APPLICATION FOR
AMENDMENT OF PLAN UNDER SECTION 12A OF
THE TOWN PLANNING ORDINANCE
(CAP.131)

**Proposed Amendment to
The Approved Kwu Tung North Outline Zoning Plan No. S/KTN/2
for Rezoning "Comprehensive Development Area" ("CDA") Zone
to "Residential (B)(1)" ("R(B)(1)") and "Residential (C)(1)" ("R(C)(1)") Zones
At Lot Nos. 684RP, 705RP, 706RP, 709RP(Part),
711RP (Part), 712, 713RP, 714RP, 715, 716, 717RP(Part), 718RP(Part), 719,
721RP(Part) and 2158RP(Part) in D.D. 92
and adjoining Government Land
Kwu Tung North, New Territories**

**Proposed Amendment to
The Approved Kwu Tung North Outline Zoning Plan No. S/KTN/2
for Rezoning "Comprehensive Development Area" ("CDA") Zone
to "Residential (B)(1)" ("R(B)(1)") and "Residential (C)(1)" ("R(C)(1)") Zones
At Lot Nos. 684RP, 705RP, 706RP, 709RP(Part),
711RP(Part), 712, 713RP, 714RP, 715, 716, 717RP(Part), 718RP(Part), 719, 721RP(Part) and
2158RP(Part) in D.D. 92
and adjoining Government Land
Kwu Tung North, New Territories
(Planning Application No. Y/KTN/2)**

Figure 1. Shortest distance between the application site and the OU(Nature Park) zone.

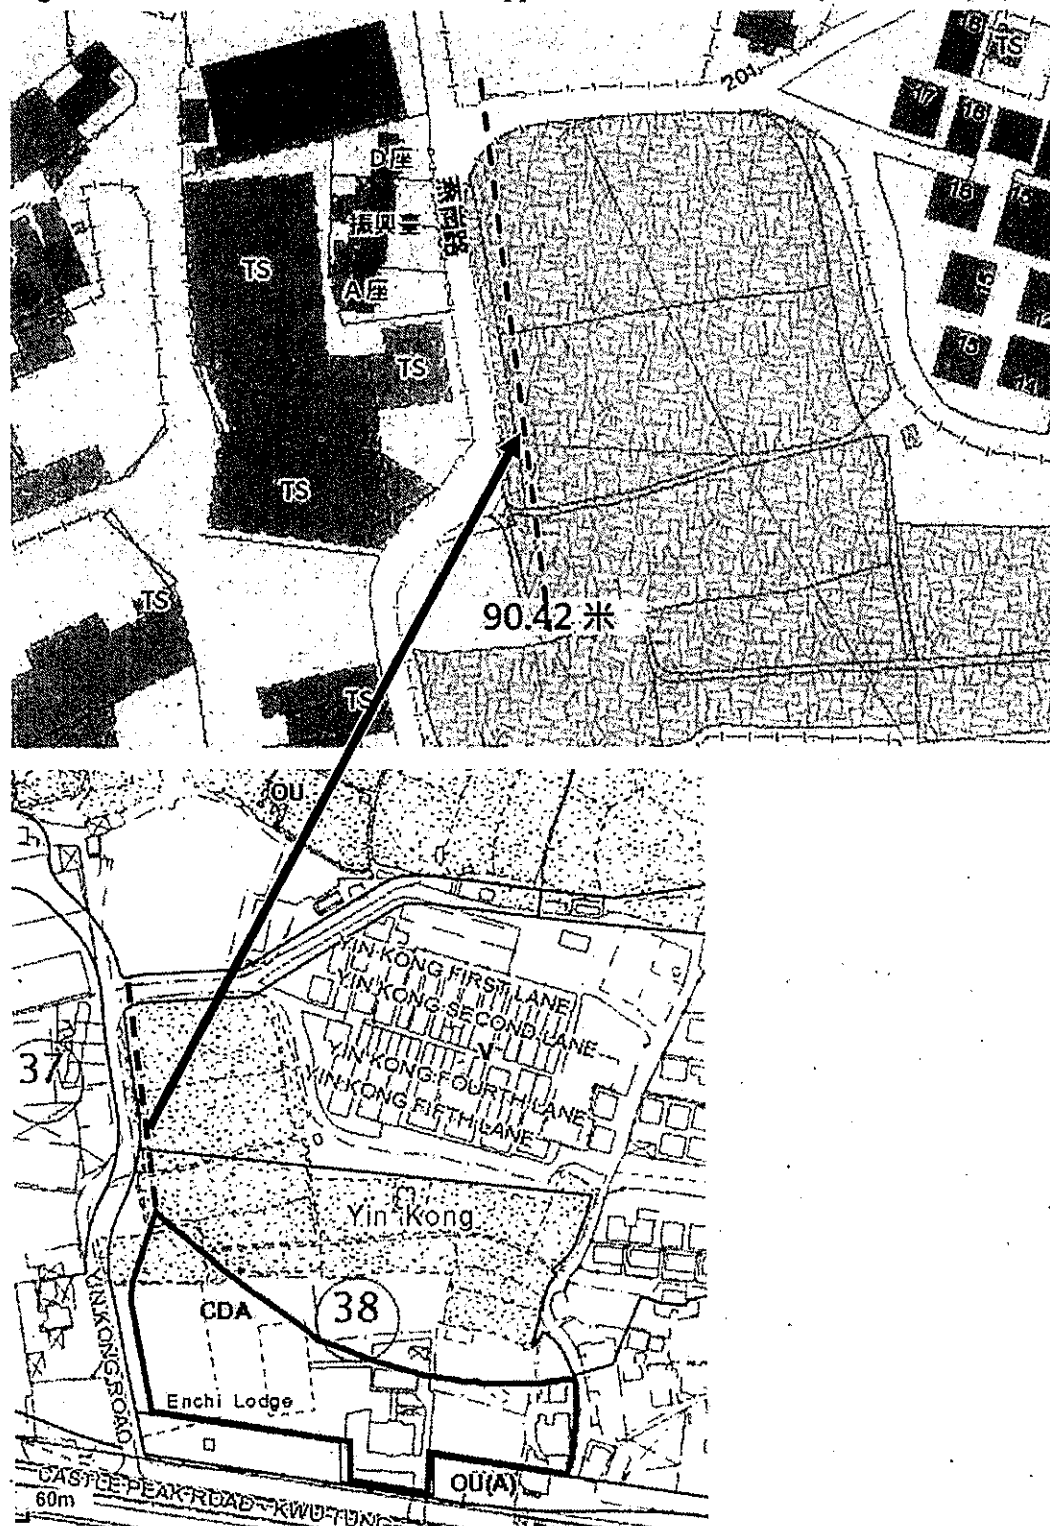
3. Based on the measurement using the tool from the GeoInfo Map of Lands Department, the shortest distance between the application site and the Other Specified Uses (Nature Park) (OU(Nature Park)) zone, which is to the north of the site, would be less than 100 m (see Figure 1).

Figure 2. 'Urban Design and Landscape Framework' of the Kwo Tung North area.

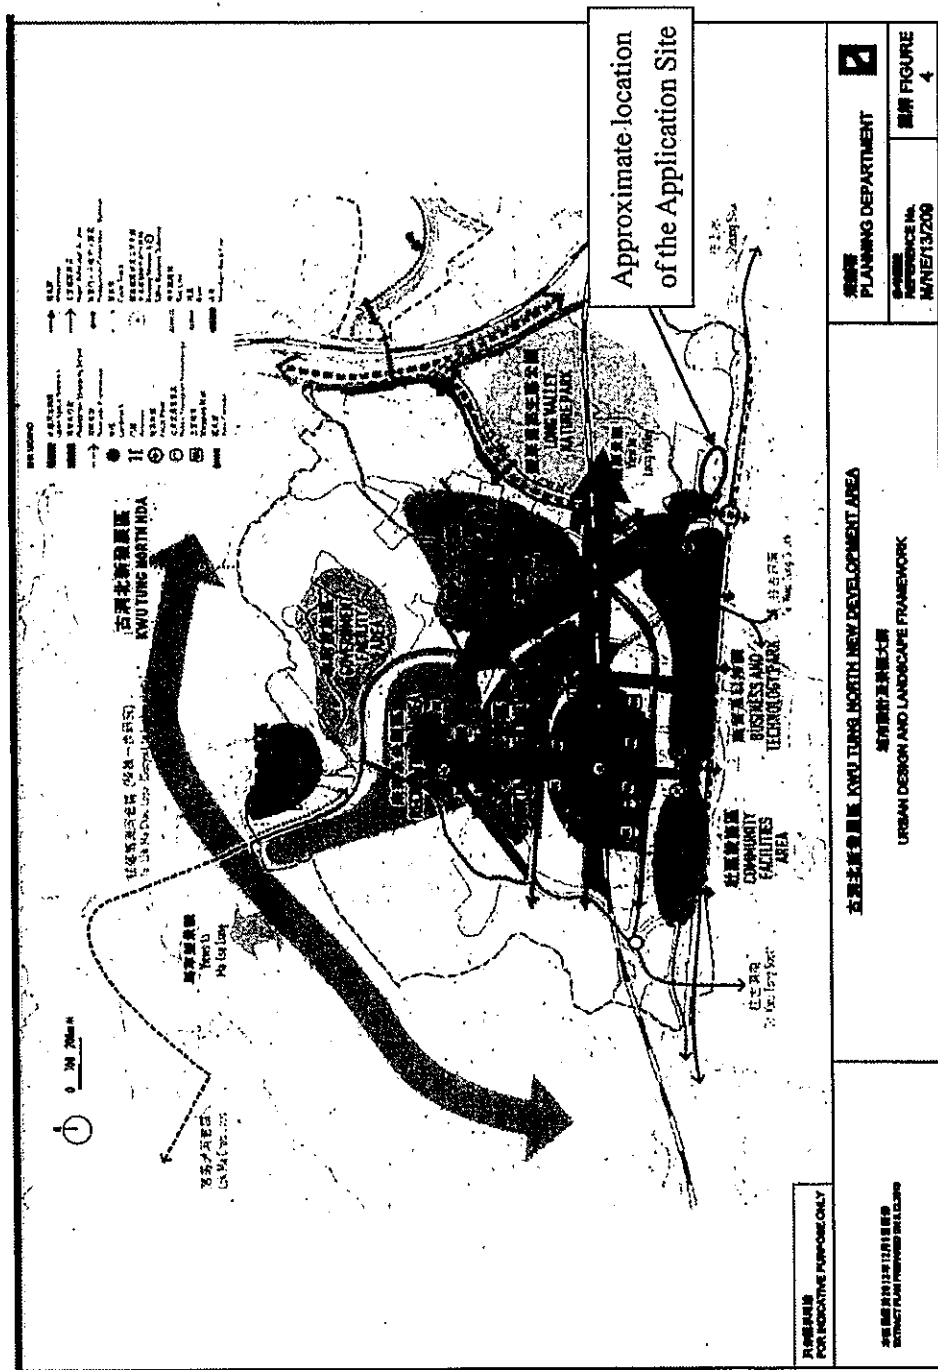
7. Figure 4 of the OZP shows the 'Urban Design and Landscape Framework' of the Kwu Tung North area. This figure is reproduced in this letter as Figure 2 and the location of the current application is also shown in this figure.

Figure 1. Shortest distance between the application site and the OU(Nature Park) zone.

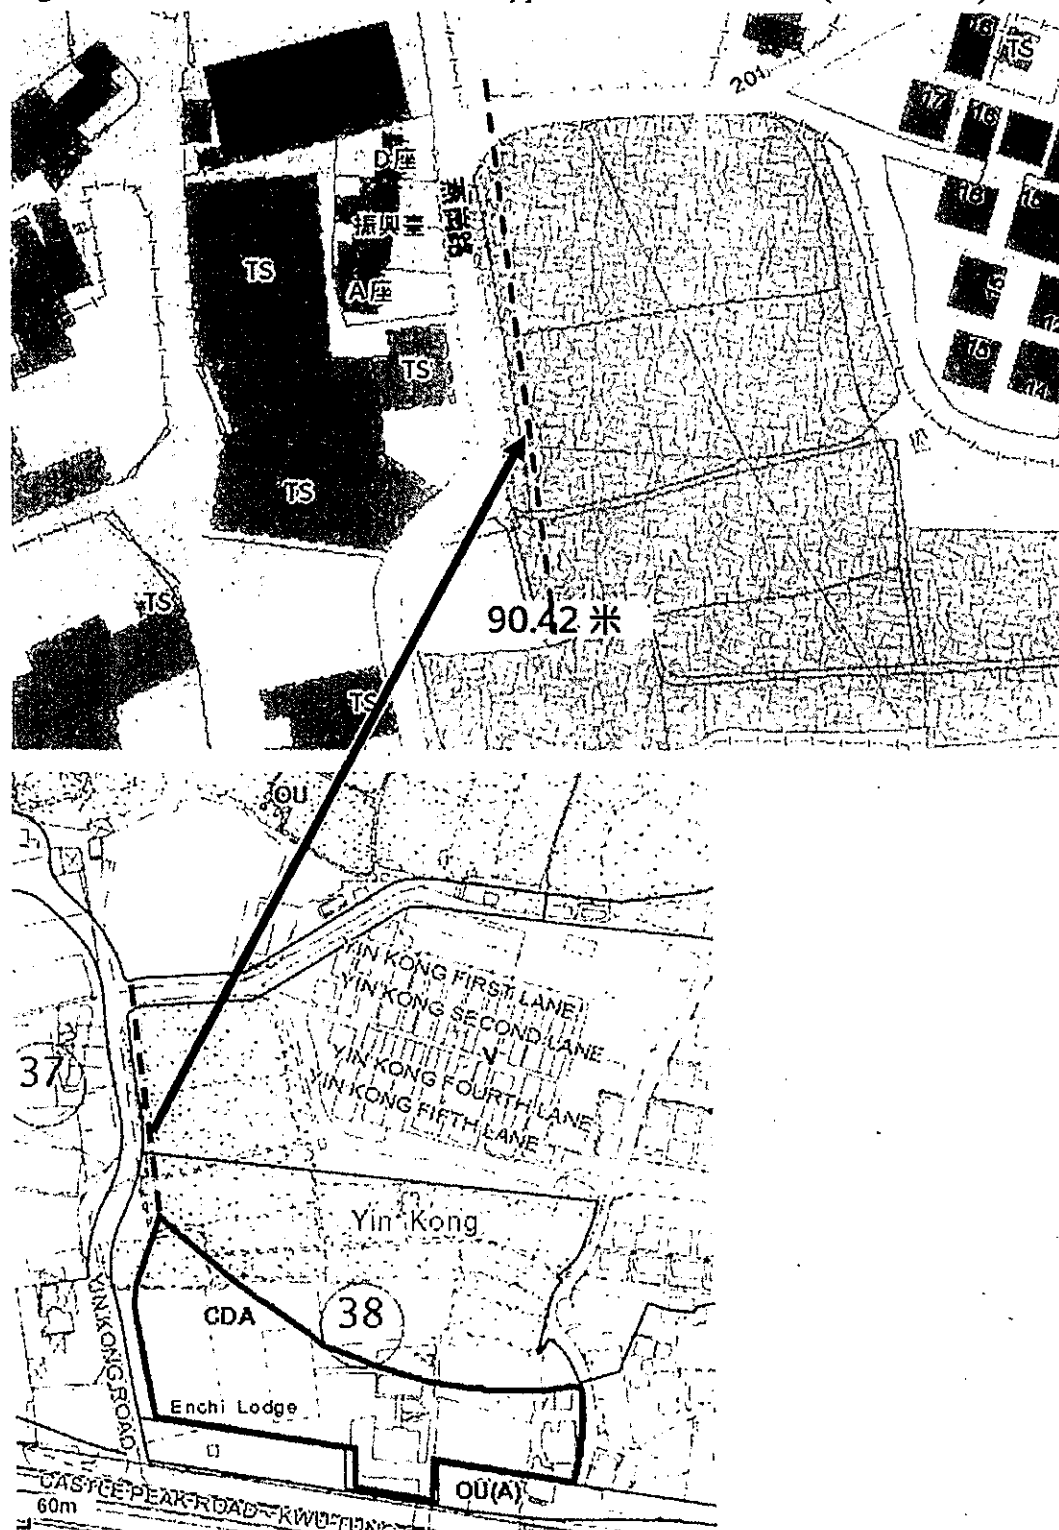
3. Based on the measurement using the tool from the GeoInfo Map of Lands Department, the shortest distance between the application site and the Other Specified Uses (Nature Park) (OU(Nature Park)) zone, which is to the north of the site, would be less than 100 m (see Figure 1).

Figure 2. 'Urban Design and Landscape Framework' of the Kwo Tung North area.

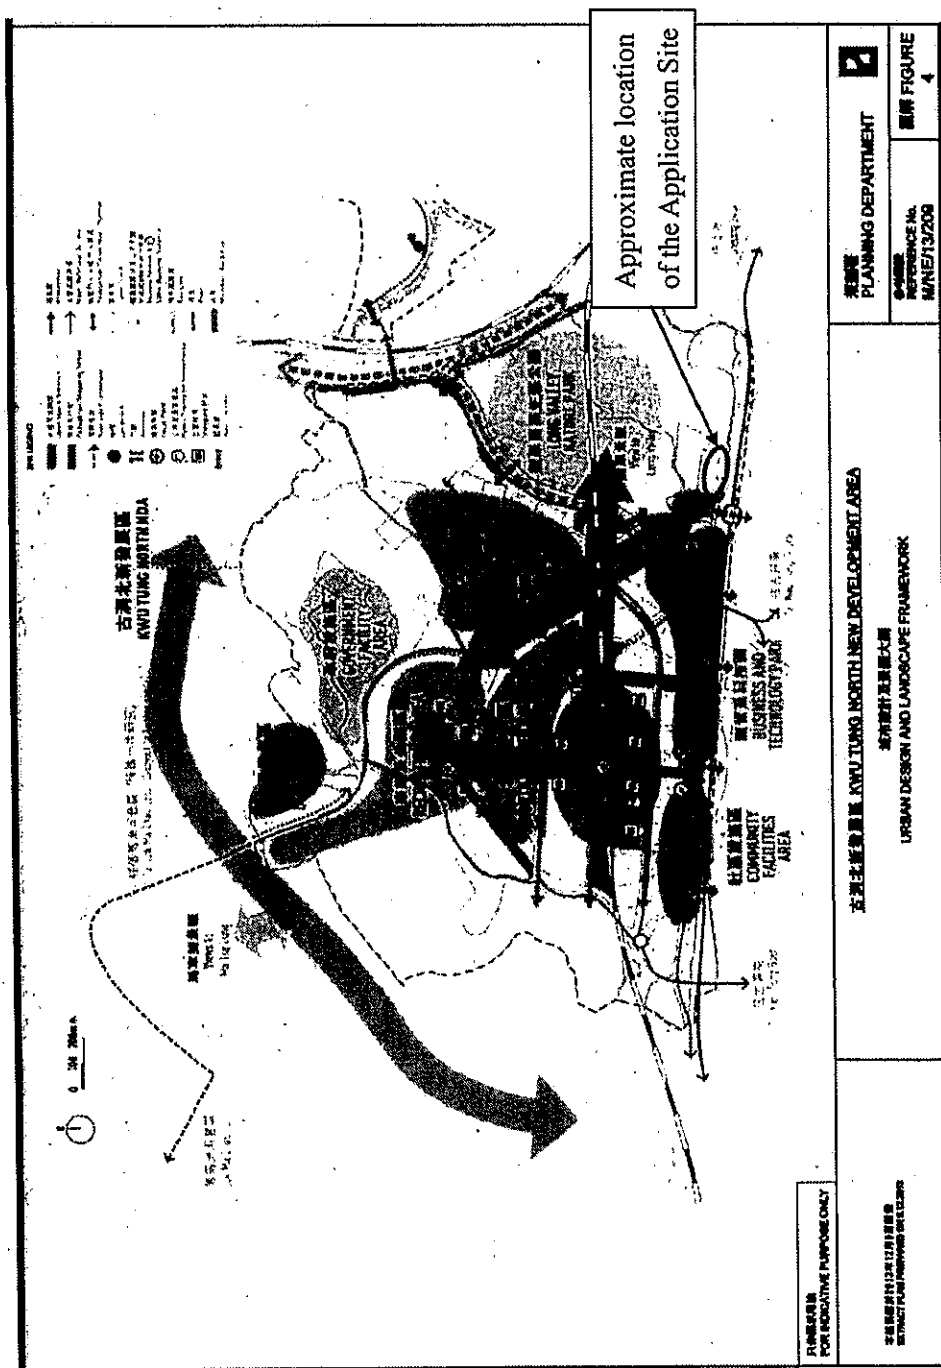
7. Figure 4 of the OZP shows the 'Urban Design and Landscape Framework' of the Kwu Tung North area. This figure is reproduced in this letter as Figure 2 and the location of the current application is also shown in this figure.
